CONTRACT TITLE: K_08 REHABILITATION OF SAUDI MATERNITY HOSPITAL

Identification number: CIG 94103090A7

ASKED QUESTIONS AND CLARIFICATIONS

LEGENDA

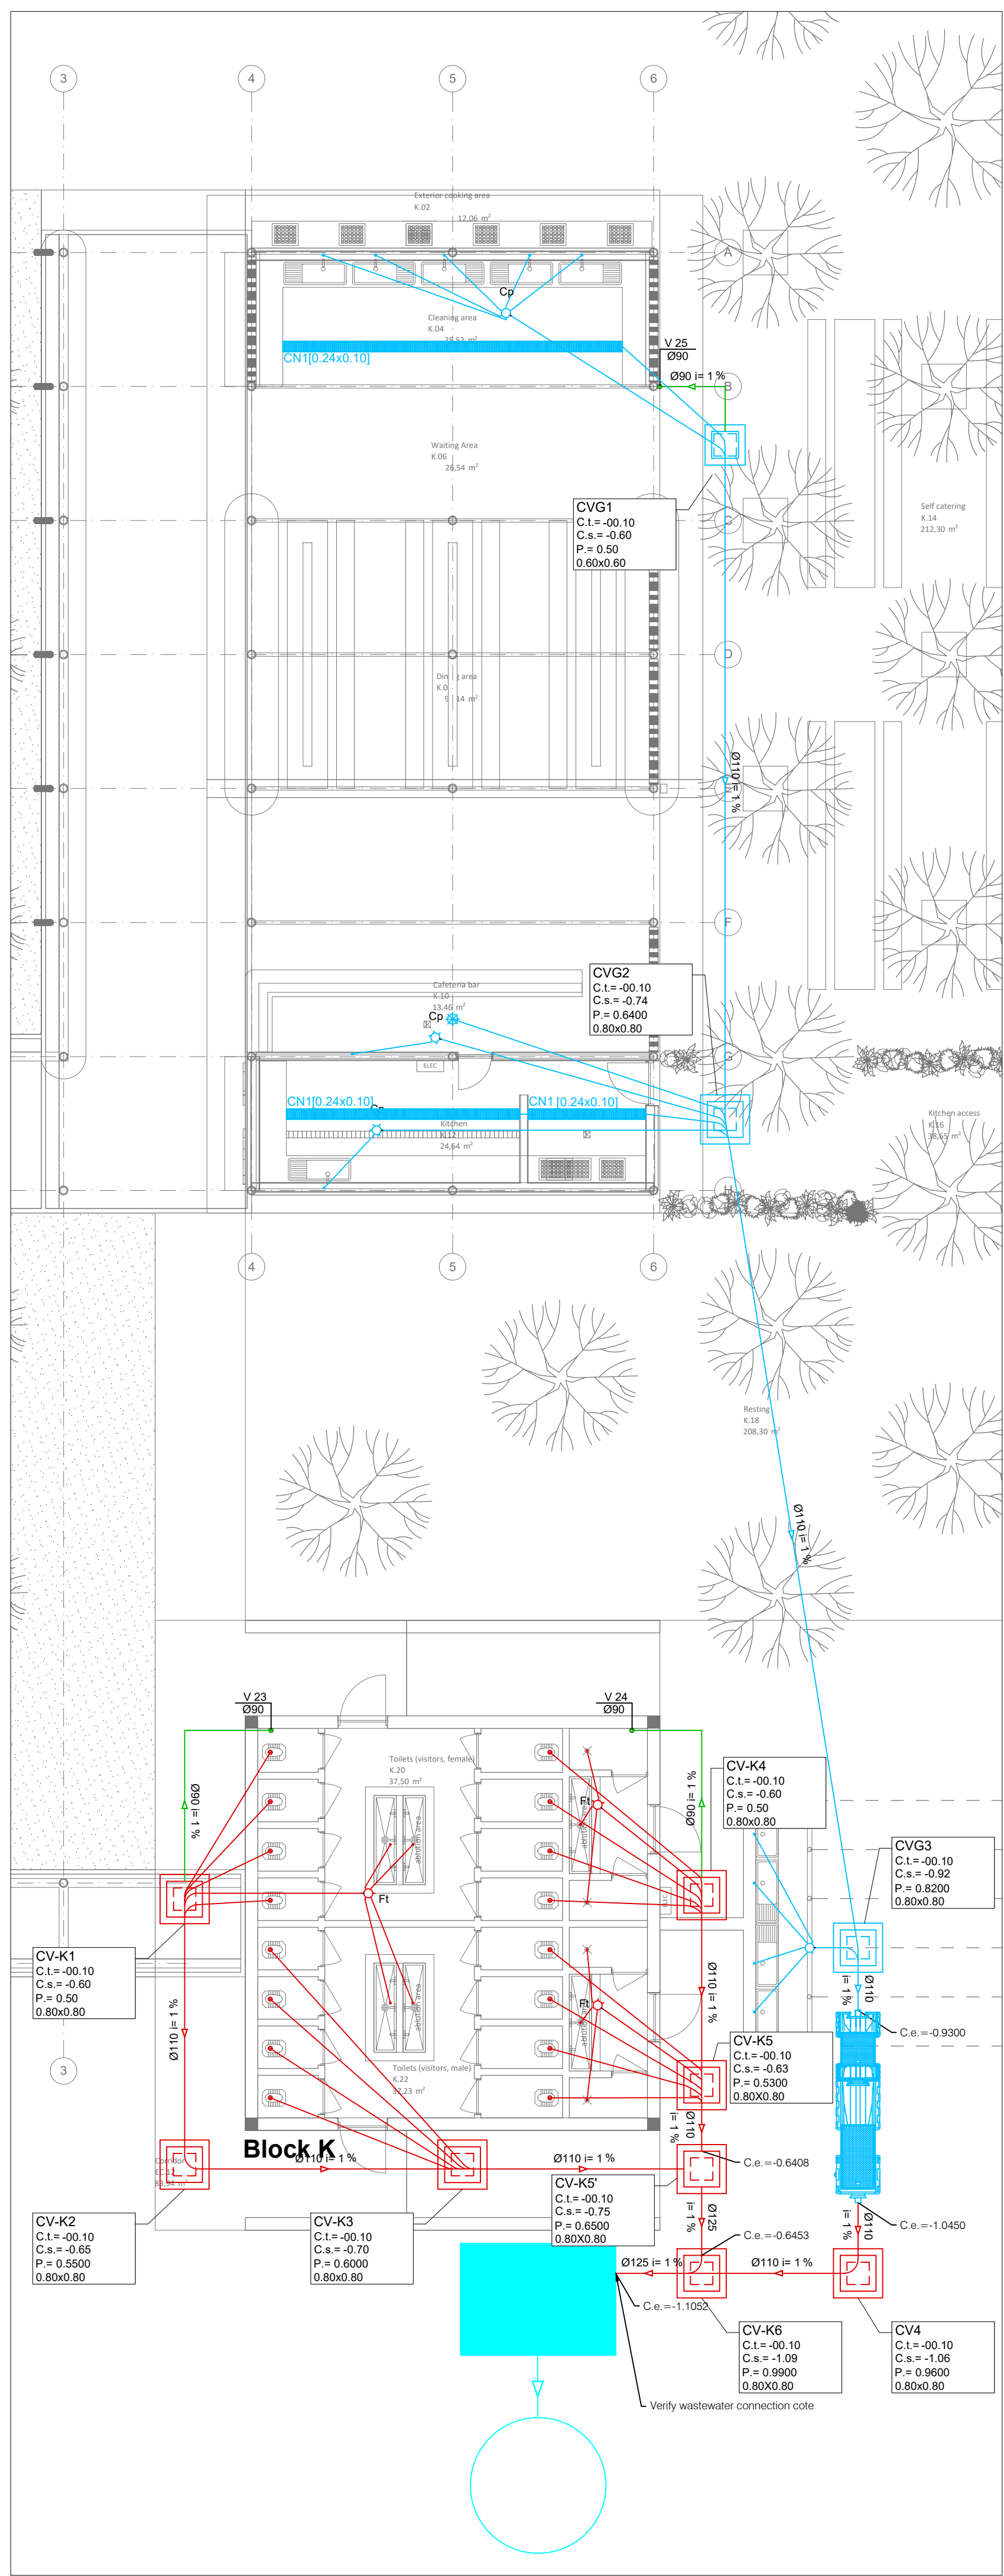
We kindly ask you to specify the dimension of the septic tank (item No.5.1.2.6 – waste water- Block L).

- The dimension of the septic tank is (7.10 L X 2.50 W X 2.30 D), for more confirmation please see drawing No:
 - VOLUME 5 DESIGN Unpack 7 02-Engineering 05-Hydraulic Drawings HWD.01.PLT003.PDF.
 - Drawing name: Ground Floor-Blocks C, J, K and L.
 - And also you can see attached PDF sheet (HWD.01.PLT.003-Ground Floor C_J_K_L) in red rectangular at the Centre.
